CITY OF LATHRUP VILLAGE
PLANNING COMMISSION AGENDA
Tuesday, April 21, 2020
7:00 p.m.

Site Plan Review

Site: 26710-26780 Southfield Road
Applicant: Sam Surnow/ Surnow Company LLC
Plan Date: 3/23/20
Zoning: CV – Commercial Vehicular
Parcel ID: 24-24-103-032
Proposal: Façade Renovation

sheet title:
Existing &
Proposed
Elevations

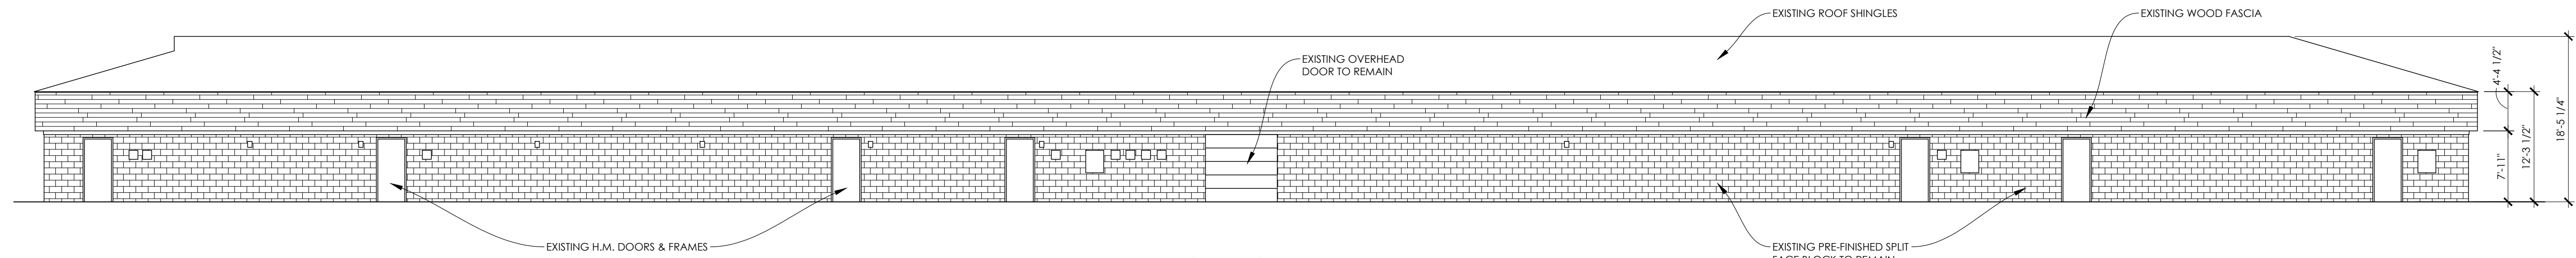
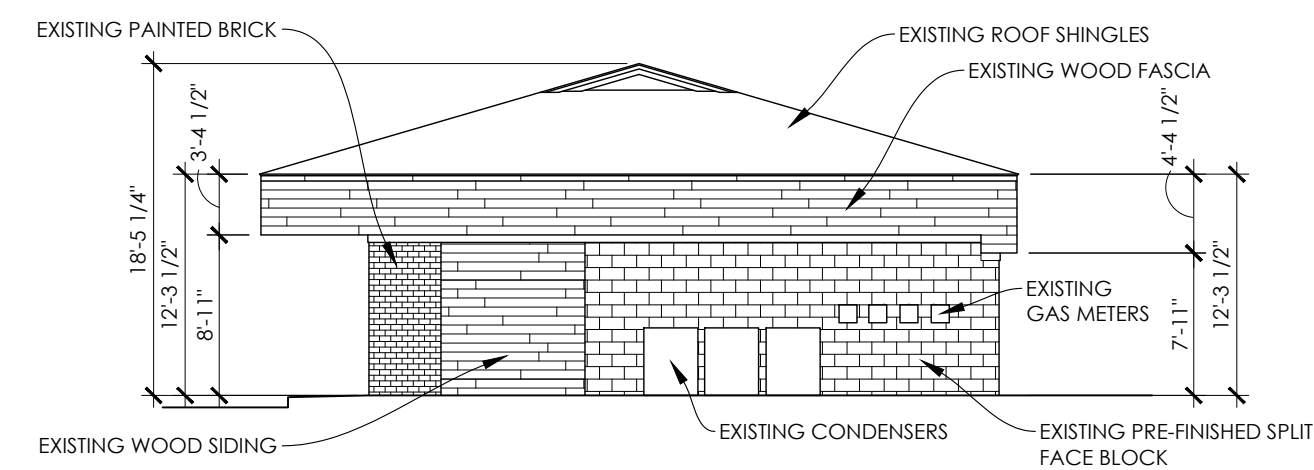
5. **Use.** Uses will remain consistent with existing building.
6. **Building Materials.** The Applicant is proposing to update the façade of the building with new materials. The new façade includes Nichiha fiber cement panels, cultured stone, metal ribbed panels, and vinyl fabric awnings to replace the existing wood fascia. Per Section 5.4, all permanent buildings and exterior walls shall be either brick, natural stone, masonry material, or a combination thereof. All other materials must meet the durability, strength, and rate of absorption standards. The applicant submitted detailed material profiles for the Nichiha fiber cement panels, cultured stone, and metal ribbed panels which appear to confirm that the materials meet the standards. **The Planning Commission may wish to discuss these materials further with the applicant.**

7. **Building Height.** Applicant is proposing to replace the existing roof as well as increase the west elevation building height with a parapet wall to 26 ft with alternating storefronts increased to 20 ft. The maximum building height in the Commercial Vehicular district is 30 ft, therefore the proposed façade is in compliance with the standards.
